# Regent's Park Estate Supporting Planning Statement July 2019 Tibbalds planning and urban design

- 1.1 This statement has been prepared by Tibbalds Planning and Urban Design on behalf of the London Borough of Camden ("the applicant"), in support of an application for a minor material amendment under Section 73 of the Town and Country Planning Act 1990, which is submitted to the London Borough of Camden ("the Council").
- 1.2 The application seeks to vary Condition 2 (approved drawings) of the planning permission 2015/3076/P which was granted on 9 December 2015 and proposed the following:

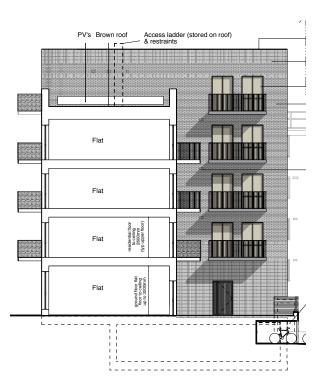
3.5 The relocation of a first floor window on the **south elevation** at DCH.

- 3.6 The relocation of a first floor window and modification to a ground floor door on the **north elevation** at DCH.
- 3.7 The mirroring of flat front entrance door to plot 1 on ground floor on north elevation at DCH.

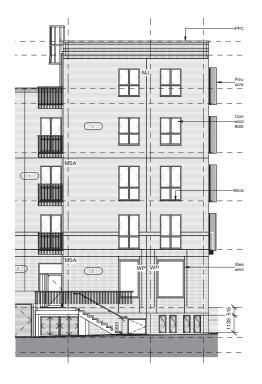
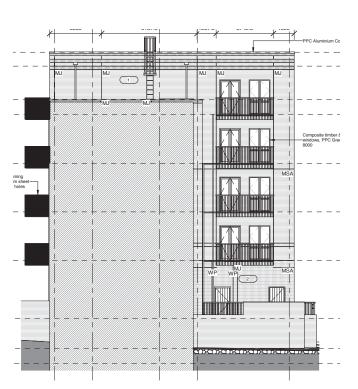
3.8 The introduction of a roof level access ladder is required for health and safety reasons, ensuring that personnel can safely access the roof for maintenance, which would otherwise not be possible.
